Addendum # 2	CMPD License Plate Recognition System RFP # 269-2025-134
---------------------	---

Subject: **Addendum # 2– RFP # 269-2025-134 – CMPD License Plate Recognition System**

Road Warrior Trailer Pictures

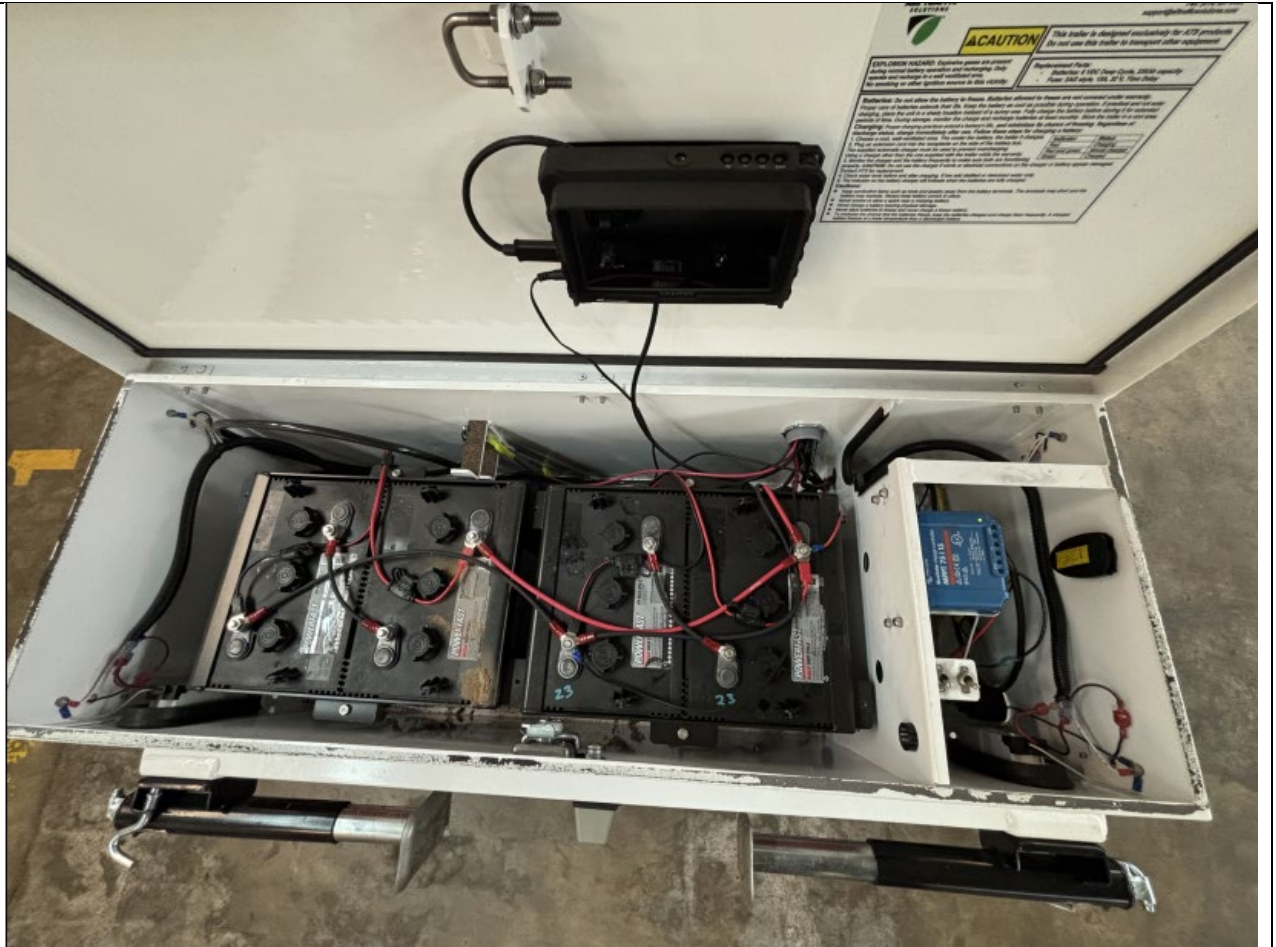
Item #	Page #	Section #	Specification	Modifications and Questions
				capture vehicles traveling at rates exceeding the speed limit. There would be interest in seeing the difference between vendor offerings.
9	18	3.5	Locations	<p>Service Provider Question: For each location, what is the breakdown in ownership of the existing structure? Is it a traffic light pole the City owns or a distribution pole a private energy company owns?</p> <p>Answer: All cameras are currently located on fabricated masts mounted primarily on City-owned poles; however, there are a few on Duke Energy-owned poles.</p>
10	18	3.6.1	Hardware	<p>Service Provider Question: Is CMPD looking for all new trailers or to update existing?</p> <p>Answer: CMPD seeks to update the existing trailers.</p>
11	18	3.6.1	Hardware	<p>Service Provider Question: Is the City looking to replace the entire trailer or add LPR to the existing trailers? If the latter, can the City provide specifications of the trailers related to charging systems? What other type of technology is connected to the trailer?</p> <p>Answer: The City is looking to replace LPR on existing trailers. Please see Attachment A, Road Warrior Pictures, for additional information.</p>

12	18	3.6.1	Hardware	<p>Service Provider Question: Will the Vendor be expected to provide the 14 mobile cameras (road warrior) trailers? What are the specs and functional requirements of the mobile camera trailers?</p> <p>Answer: The vendor is not expected to provide 14 mobile camera trailers. The vendor is expected to provide 14 cameras for the mobile camera trailers. Please see Attachment A, Road Warrior Pictures, for additional information.</p>
13	18	3.6.1.3	Hardware	<p>Service Provider Question: Will the City require portable trailers, or simply a mounting system that can be quickly uninstalled and re-installed?</p> <p>Answer: The vendor is expected to provide 14 cameras and services for mounting the mobile camera trailers.</p>
